DOCKET NO. 50-409

SUBJECT: DAIRYLAND POWER COOPERATIVE (DPC)
LA CROSSE BOILING WATER REACTOR (LACBWR)
PROVISIONAL OPERATING LICENSE NO. DPR-45
INACCURACIES REPORTED IN NUREG/CR-2497

- REFERENCES: (1) NUREG/CR-2497, Volume 1, ORNL/NSIC-182/V1,
Precursors to Potential Severe Core Damage Accidents:
1969-1979, A Status Report, Appendices A, C, D, and E
(2) NUREG/CR-2497, Volume 2, ORNL/NSIC-182/V2,
Precursors to Potential Severe Core Damage Accidents:
1969-1979, A Status Report, Appendix B

NSIC 61043 - Sequence of Interest for Plant Electrical Power Failure at La Crosse

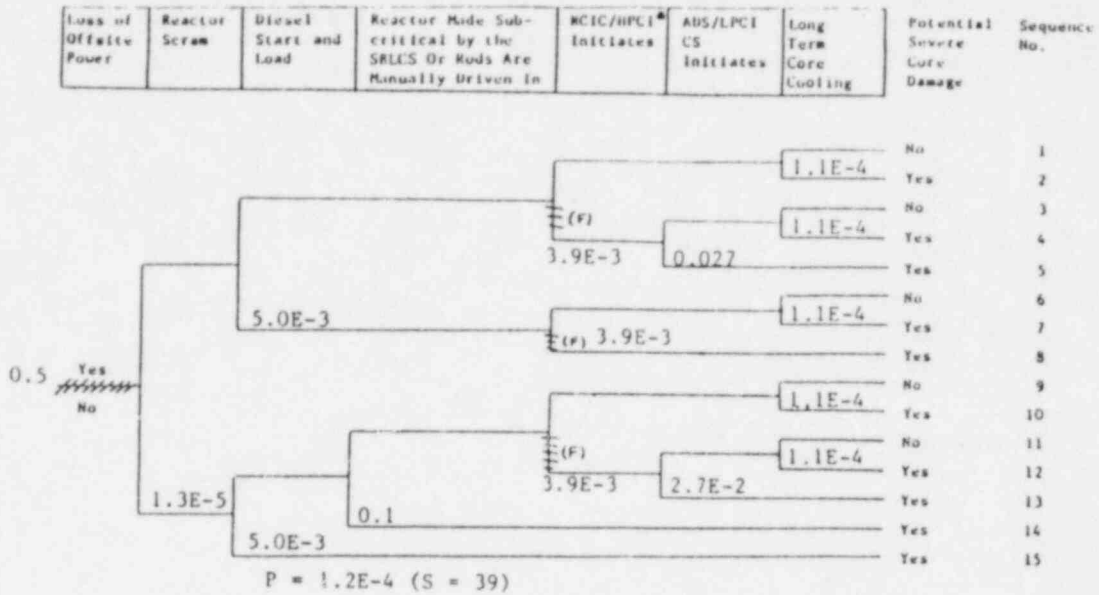
The event trees used for the sequence of interest and analyses for the three incidents are attached. The assumptions were made that, (1) the shutdown condenser and condensate pumps were the equivalent of RCIC and HPCI, and (2) operation of the shutdown condenser is dependent on the condensate pumps. Both of these assumptions are erroneous.

The dependence of the shutdown condenser on the condensate pumps is totally nonexistent except possibly in the minds of the authors of this report. The condensate pumps are associated with the main condenser. Since they are not supplied by emergency power, they are always unavailable during a loss of

offsite power. The descriptions of two of the incidents, including the March 1971 event, specifically mention that the shutdown condenser and the emergency core spray pump were used. Yet the event tree for the March, 1971 incident has the shutdown condenser as failed. The shutdown condenser has never failed to operate when needed or during testing. The failure rate for the shutdown condenser and the High Pressure Core Spray System should be re-evaluated for all three events, rather than using the RCIC/HPCI failure rate of 3.9×10^{-3} or 1.0, as used in the March 1971 event analysis. There are significant differences between the shutdown condenser and HPCS at LACBWR and GE's HPCI and RCIC.

NSIC 63129 - Sequence of Interest for A Scram Caused by Electrical Load Rejection at La Crosse

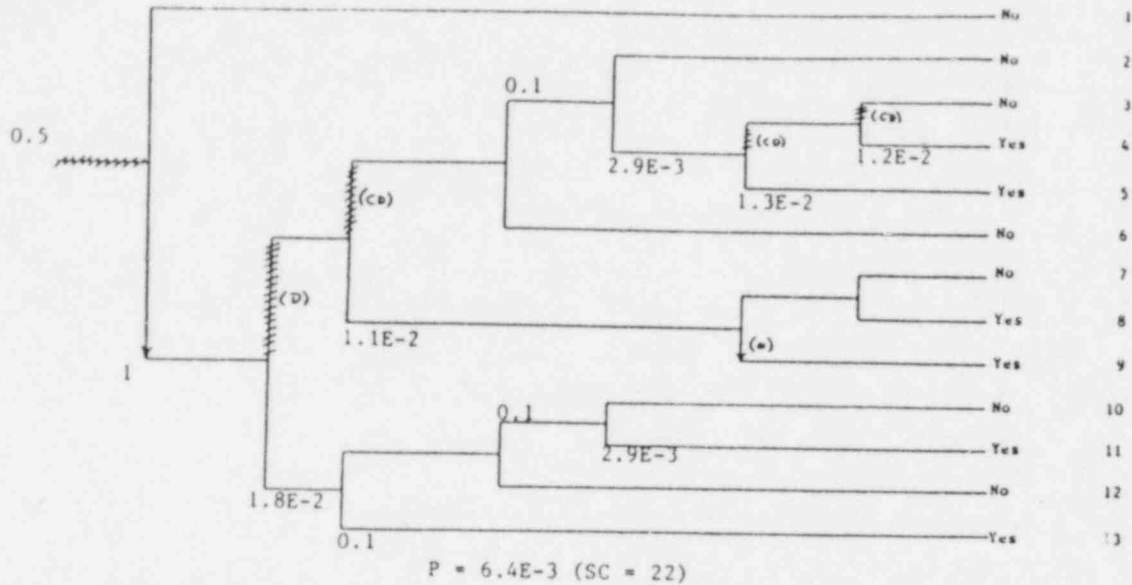
An additional error contained in the event is the failure rate used for the reactor being made subcritical by the SBLCS or rods being manually driven into the core. Table C.1, "Initiating Event Frequency and Function Failure Probability Estimates" states that for a BWR loss of offsite power, the failure to make reactor subcritical by means other than a scram is taken as 5×10^{-3} per demand. In the event trees, however, a failure probability of 0.1 was used. LACBWR has a Boron Inject Sytem, rather than a SBLCS, but the failure rate should not be affected to that extent by the difference.

NSIC 75074 - Sequence of Interest for Loss of Load and Iodine Release at LaCrosse

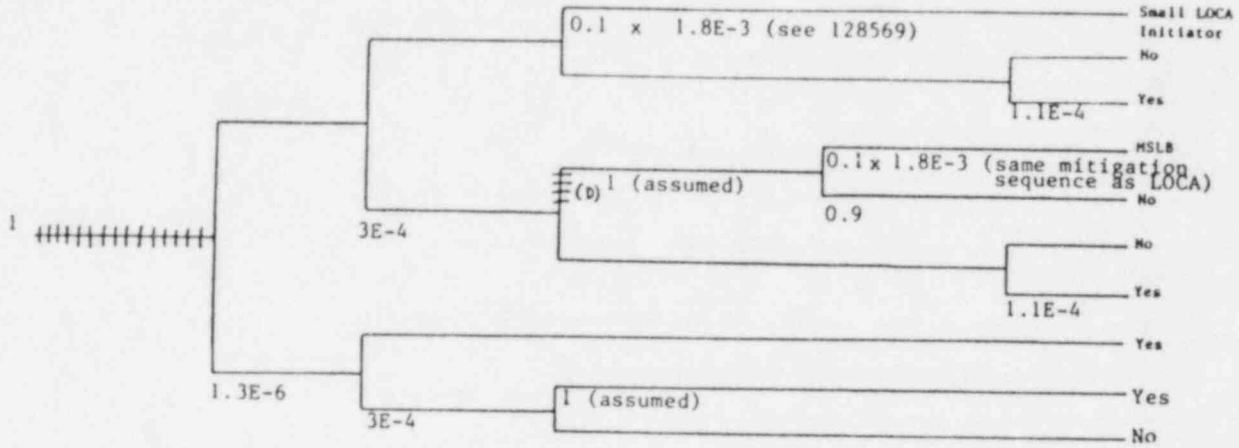
The event trees do not allow for the use of a low pressure core spray system if the emergency diesel generator fails to start. At LACBWR, the Alternate Core Spray System does not require offsite or onsite AC power to function. River water is supplied to the reactor from one of two diesel-driven pumps. Therefore, it is available for use if the diesel generators do not start. Also, the Low Pressure Core Spray Subsystem can be used at low reactor pressure. It consists of a gravity feed system from the Overhead Storage Tank in the Containment Building. The Low Pressure Core Spray Valve fails open on loss of power, so it is usable once the reactor is depressurized, even if the diesel generators do not start. There are additional differences between LACBWR's systems used for low pressure emergency cooling (Manual Depressurization System, Alternate Core Spray System and Low Pressure Core Spray Subsystem) and the Automatic Depressurization System, Low Pressure Coolant Injection, and Low Pressure Core Spray utilized in the study. These differences may affect the failure rate which was dominated by ADS failures. There has never been a simultaneous failure of both MDS Valves at LACBWR.
